## MANDATORY REFERRAL REPORT NO. 99-40 CHARLOTTE-MECKLENBURG PLANNING COMMISSION

# Purchase of Property by the Public Library December 1999

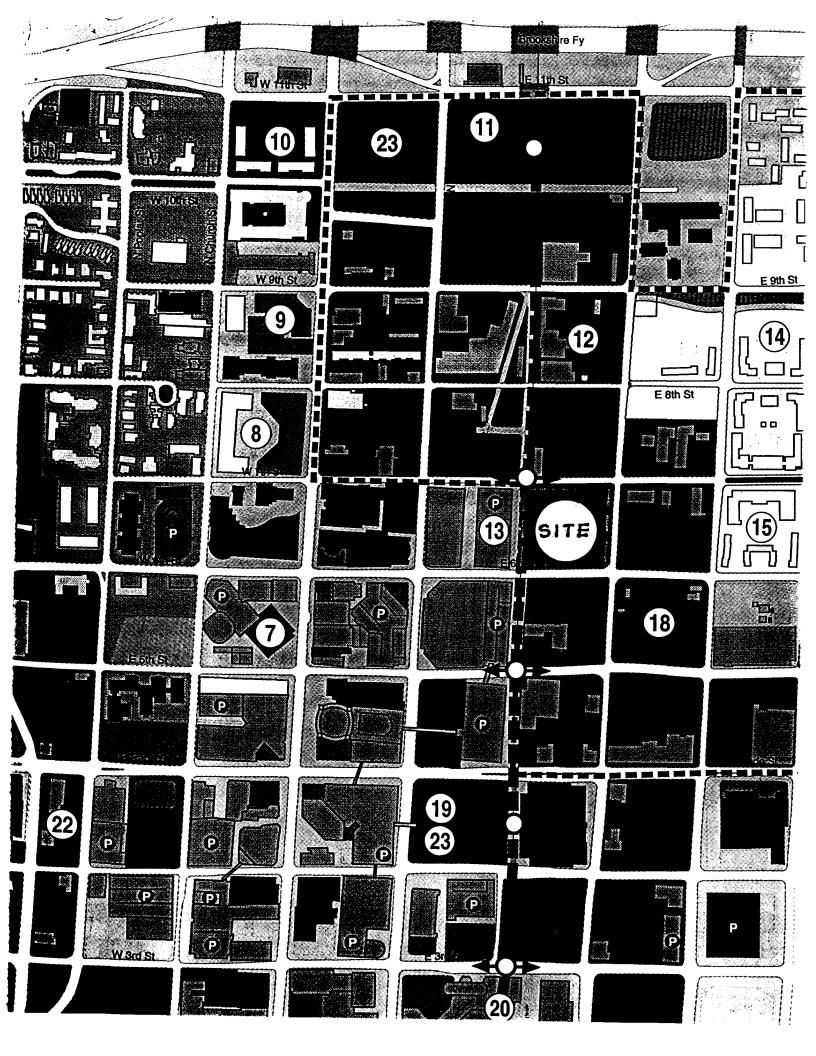
The massing model that was created as a tool to understand the elements of the project illustrates several potential concerns. The project proposes to house a 400 car parking structure. It's position on the site and relationship to the street has the potential to become a negative feature if it is not carefully designed. The close proximity to two other existing large parking structures suggests that additional study be undertaken to see if shared parking could be arranged. The building program shows a building massing which covers the entire city block site. The design of this facility will be a major urban design challenge.

The project proposes to include a 400 car parking structure. The close proximity to two other existing large parking structures suggests that additional study be undertaken to see if some type of shared parking could be made.

Planning Staff supports purchase of this property with the stipulation that the following design measures be addressed:

- 2. If a parking structure is included in the program, it should have the building wrap around the deck so the parking structure will front the street. The parking then becomes an integral component of the building.

- 3. The building mass must be broken down so it is not perceived as a big box next to the street.
- 4. The design of the facility must contain an interactive connection along the trolley corridor. The building must have windows, entrances, and program activities that front the corridor.

- 5. The building design must be done in a manner that uses inside the building are reflected in the character of the exterior. In other words the building architecture must be animated, be made of materials that invoke the spirit of the activities within, and have elements and scale of interest to children.

- 6. The project must relate to the street and trolley corridor with strong pedestrian edges.

7. The building and site design must have patron safety as a component, but these measures should not overburden the building's architectural character and uniqueness.
